PCN#20180327000
Conversion to smaller reel (13" to 7") and associated packing materials
on Select Devices currently shipped in 13" reels
Final Change Notification

PCN Number:	20180327000	PCN Date:	April 19, 2018
Title:	Conversion to smaller reel (13" to 7") and associated packing materials on Selected Devices currently shipped in 13" reels		
Customer Contact:	PCN Manager	Dept:	Quality Services
Proposed 1st Ship Date:	July 19, 2018		
Change Type:			
<input type="checkbox"/>	Assembly Site	<input type="checkbox"/>	Assembly Process
<input type="checkbox"/>	Design	<input type="checkbox"/>	Electrical Specification
<input type="checkbox"/>	Test Site	<input checked="" type="checkbox"/>	Packing/Shipping/Labeling
<input type="checkbox"/>	Wafer Bump Site	<input type="checkbox"/>	Wafer Bump Material
<input type="checkbox"/>	Wafer Fab Site	<input type="checkbox"/>	Wafer Fab Materials
<input type="checkbox"/>		<input type="checkbox"/>	Part number change
<input type="checkbox"/>		<input type="checkbox"/>	Assembly Materials
<input type="checkbox"/>		<input type="checkbox"/>	Mechanical Specification

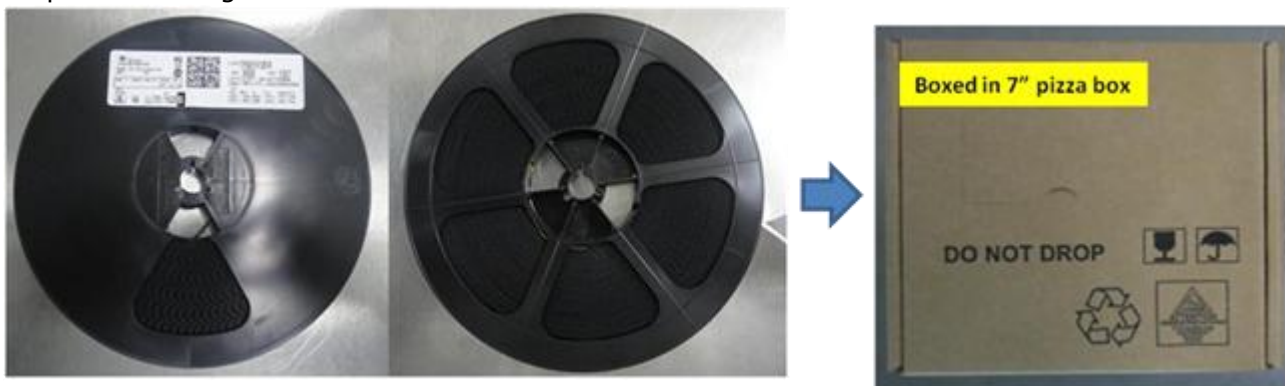
Conversion to a smaller reel size for selected product currently shipped in 13" reels with small reel quantities. The Moisture Barrier Bag (MBB) and pizza box will be switched to accommodate the smaller reel size. All new packing materials are qualified and currently in use for other products. Pack material differences are shown below:

Current Packing – 13 inch reel diameter

Proposed Packing – 7 inch reel diameter

Pack BOM	From	To
Reel Diameter	13"/4220831	7"/4203839
Pizza Box	4207162	4206831
Pack Filler	4208630	4221303

Reason for Change:
Quality improvement. There has been reported quality issues with reels shipped with less than half full of product causing reel deformation.
Anticipated impact on Fit, Form, Function, Quality or Reliability (positive / negative):
None
Changes to product identification resulting from this PCN:
Product will be shipped in smaller (7") Reels and packing materials
Product Affected:
See Page 2
